## Agenda Item # 3

### SUB-003195-2025

Airgas South Subdivision

## AIRGAS SOUTH SUBDIVISION

## DETAIL SITE PLAN

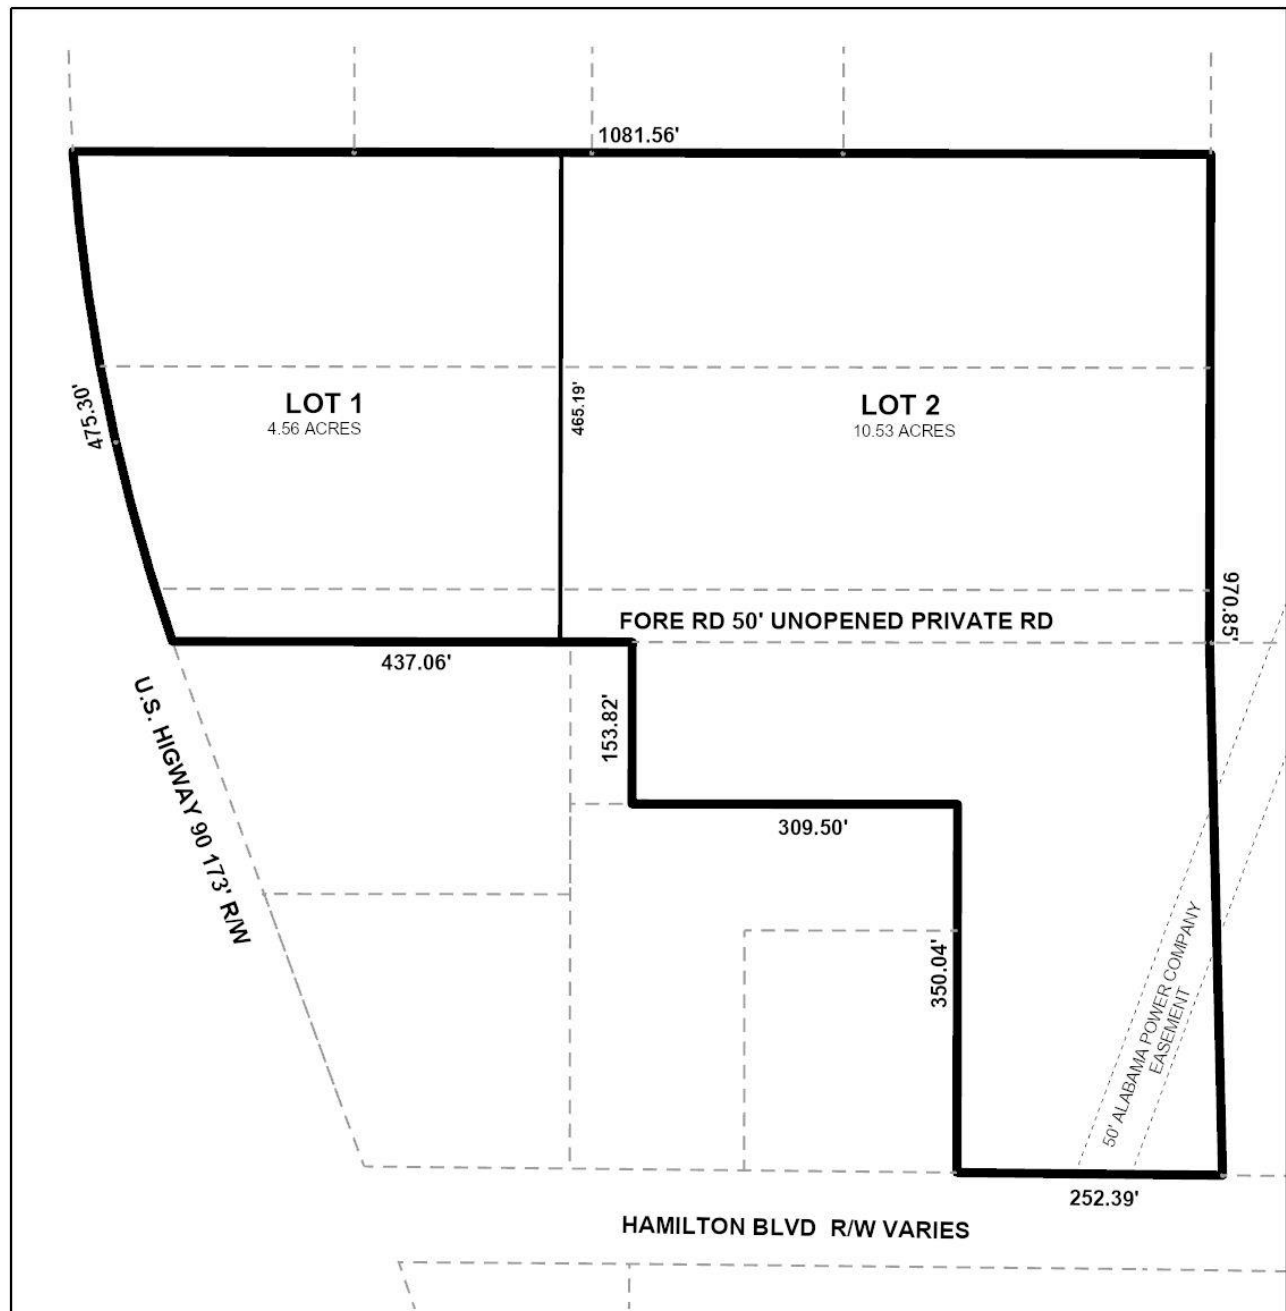
The lot sizes are labeled in both square feet and acres, and should be retained on the Final Plat, if approved.

The preliminary plat does not depict the 25-foot front yard minimum building setback line for either of the proposed lots. If approved, the Final Plat should be revised to depict the setback as required by Section 64-2-21 of the Unified Development Code (UDC).

Proposed Lot 2 has an existing 50-foot Alabama Power easement. If approved, a note should be placed on the Final Plat stating that no structures are allowed in any easements without the permission of the easement holder.

1. Revision of the plat to depict the distance from the subject site to the centerline of Hamilton Boulevard;
2. Placement of a note on the Final Plat stating that at such a time as Fore Road is developed, it will be required to be developed to City Standards, per Section 9.D. of the Subdivision Regulations;

3. Retention of the lot size label in both square feet and acres on the Final Plat;
4. Revision of the plat to depict the 25-foot front yard minimum building setback along both street frontages;

5. Placement of a note on the Final Plat stating that no structures are allowed in any easements without the permission of the easement holder
6. Compliance with all Engineering comments noted in this staff report;
